REGIONAL REVIEW NOTIFICATION

DATE: May 29, 2020 **ARC REVIEW CODE**: R2005291

Name of Proposal: 1020 Spring Street (DRI #3094)

1020 SPRING STREET DRI City of Atlanta Natural Resources Group Review Comments May 27, 2020

DRI SITE PLAN HEET NUMBER

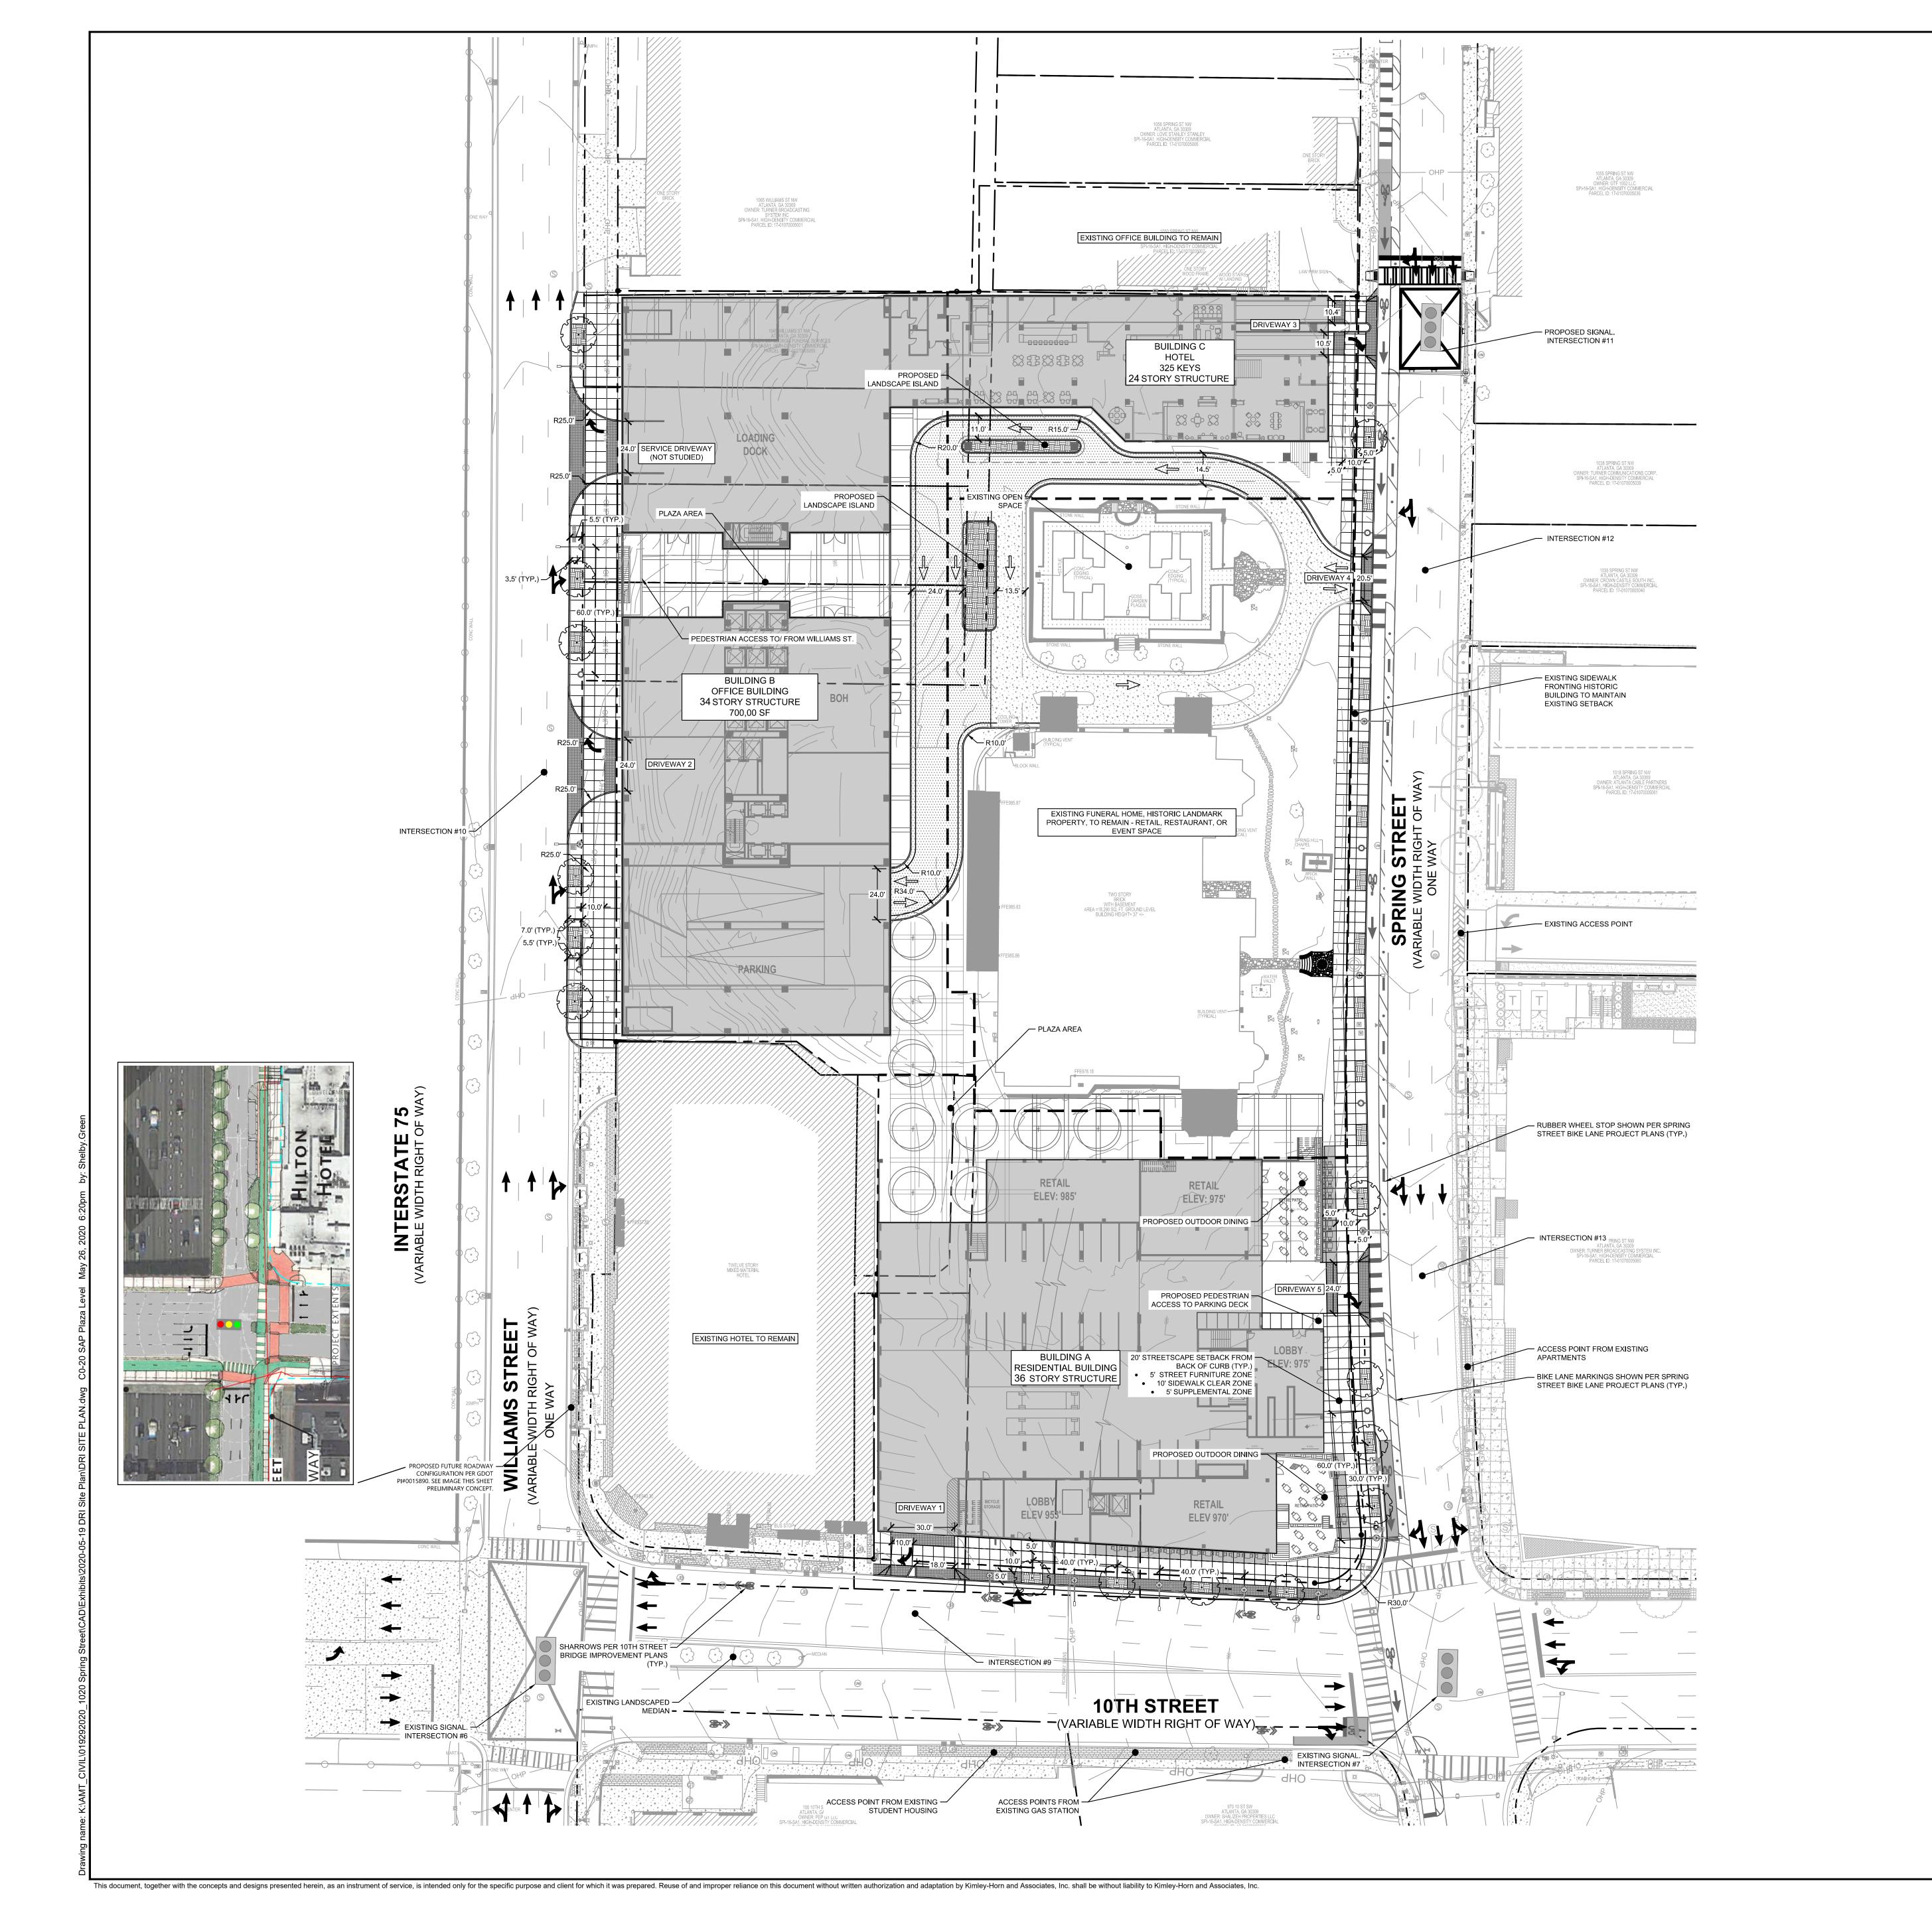
This project falls within the boundary for the Midtown Development Review Committee. Members of the committee and Midtown Alliance identified multiple improvements that would improve the project's compatibility with the goals of the SPI-16 zoning code and the City of Atlanta's Transportation Plan. ARC staff agrees with these recommendations. They include:

- Establishing a clear east-west pedestrian and bike connection across the middle of the site, including a stairway with bike runnels to navigate the grade separation between Williams Street and the plaza between Buildings B and C.
- Altering or eliminating the proposed Driveway 1 on 10th Street, which introduces an additional
 conflict area for pedestrians and drivers, and sits directly adjacent to the driveway for the existing
 hotel next door.
- Reducing the number of proposed driveways on Spring Street and install a new traffic signal and pedestrian crossing at Driveway 3. This will have the benefit of reducing conflicts with drivers and pedestrians on the sidewalk, as well as further protection for the future protected bicycle facility on Spring Street.

To the maximum extent possible, new driveways and intersection corners where pedestrians will cross should be constructed with minimal curb radii to reduce speeds of turning vehicles and decrease crossing distances for pedestrians. For example, the northwest and northeast corners of the intersection of 10th Street and Spring Street have excessively long curb radii. Additional comments from ARC's Transportation Access & Mobility Group are attached.

The USGS coverage for the project area shows no streams on or near the property. No streams or other waters of the State are shown on the submitted site plan and no evidence of streams or other waters is visible in available aerial photo coverage. Any unmapped streams identified on the property may be subject to the City of Atlanta's stream buffer ordinance. Any unmapped State waters identified on the property will be subject to the State 25-foot Sediment and Erosion Control buffer.
